SERVICE PROCEDURE

**G-10513
SEPTEMBER 2010**

**SUBJECT: SAFETY RECALL
JUMP START STUD on certain 1300, 3200, 4000,
5000, 7000, 8000, 9000, CXT, MXT, LoneStar, and
ProStar model trucks built 4/23/08 thru 3/15/10 with
feature code 08WBW or 08899.**

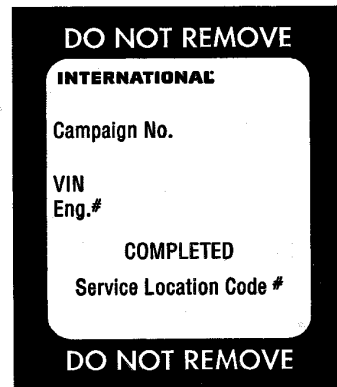
Corrosion on the jump start stud may cause an electrical short between the stud and battery box possibly resulting in a vehicle fire without warning. A vehicle fire may result in property damage, personal injury, or death.

1. Access the battery box and disconnect the ground cable from the negative terminal of the battery box.
2. If the vehicle is equipped with a jump start stud:
 - a. Disconnect the jump start stud battery cable from the jump start stud assembly.
 - b. Remove and discard the jump start stud assembly.
3. Install the new jump start stud assembly. Torque the plastic nut that holds the jump stud to the battery box to 14-16 N-m (11-12 lb-ft).
4. Install or reconnect the jump start stud battery cable. Make sure to install the protective boot and retaining clip over the cable before connecting it to the stud. Reconnect any positive battery cable connections first, negative cable connections last. Tighten the battery terminal connections to 16-20 N-m (12-15 lb-ft).

5. Install any battery cable terminal boots as applicable.
6. Close/cover battery box.
